# Access Compliance Report

## Public Rights-of-Way

### (Curb Ramps)

Intersection ID: 31746	Main Street: WASHOE_PINE_LN	Cross Street: PAPER_BIRCH_DR	Location: NE
ADA ID: 87BCB1EBC41A	Ramp Type: PerpDiag	Initial Pass/Fail: Fail	Overall Compliance: No
Severity Score: 13.75			
Codes/Mitigation Info/Possible Solution		Field Measurements/Component Compliance

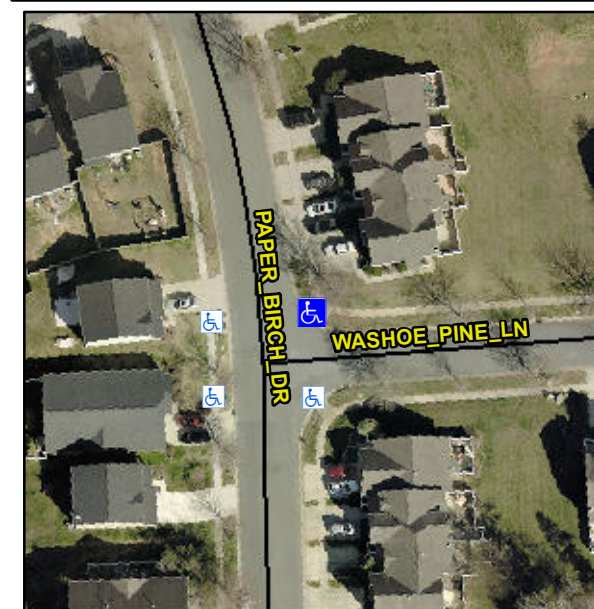
**Not Found, R304.2.2, R304.5.3**

Compliance	Description	Data	Compliance	Description	Data
N/A	Ramp Length (in)	81.5	No	Ramp Slope (%)	10.2
Yes	Ramp Width (in)	48.5	No	Ramp XSlope (%)	4.0
N/A	Flare Type LT	N/A	N/A	Flare Type RT	N/A
N/A	Flare Slope LT (%)	N/A	N/A	Flare Slope RT (%)	N/A
N/A	Flare Traversable LT?	N/A	N/A	Flare Traversable RT?	N/A
N/A	Landing Length (in)	N/A	N/A	DWS Provided?	N/A
N/A	Landing Width (in)	N/A	N/A	DWS Contrast?	N/A
N/A	Landing Slope (%)	N/A	N/A	DWS Length (in)	N/A
N/A	Landing X Slope (%)	N/A	N/A	DWS Full Width?	N/A
N/A	Landing Curb? (Y/N)	N/A	N/A	DWS Offset (in)	N/A
N/A	Shared Landing?	N/A			
N/A	Gutter Ponding?	N/A	N/A	Gutter Slope (%)	N/A
N/A	Gutter Lip Ht (in)	N/A	N/A	Gutter X Slope (%)	N/A
N/A	Painted X Walk1?	No	N/A	Painted X Walk2?	No
	X Walk 1 Direction	To W		X Walk 2 Direction	To S
N/A	X Walk 1 Width (in)	N/A	N/A	X Walk 2 Width (in)	N/A
	X Walk 1 Slope (%)	2.1		X Walk 2 Slope (%)	0.1
	X Walk 1 X Slope (%)	1.1		X Walk 2 X Slope (%)	1.6

**Remove & Replace Curb Ramp With Two New Directional Ramps or Equivalent.**
